May 9, 2019

**Re: Dollar General – SWPPP Acceptance
Pennsylvania Avenue, Southport, New York**

I have completed a review of the following submitted information for the above-referenced project regarding the Stormwater Pollution Prevention Plan (SWPPP) and stormwater management system design for that project.

LINER DETAIL

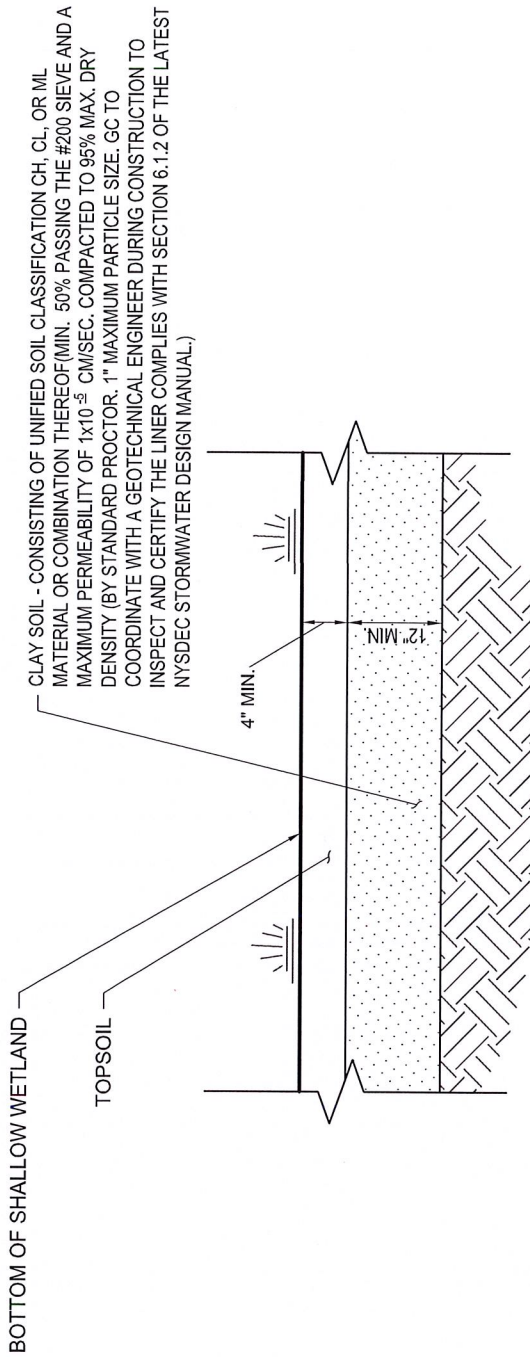
11. In regards to the Liner Detail on Sheet 13 of the Site Development Plans, that detail shall be replaced with the attached Liner Detail that was provided by Bohler Engineering in the attached May 9, 2019 e-mail.

As discussed moments ago, the attached Clay Liner Detail will supersede the one on the plans. This one changes note 2 to reflect 20 compaction tests throughout the liner for each lift.

2. INSTALLATION SHALL BE IN 6" LIFTS. TO CONFIRM THAT PROPER COMPACTION IS ACHIEVED, DENSITY TESTS SHOULD BE COMPLETED BY THE GEOTECHNICAL ENGINEER OF RECORD ON EACH LIFT OF FILL PLACED. 20 COMPACTION TESTS TO BE COMPLETED THROUGHOUT AREA OF LINER FOR EACH LIFT.
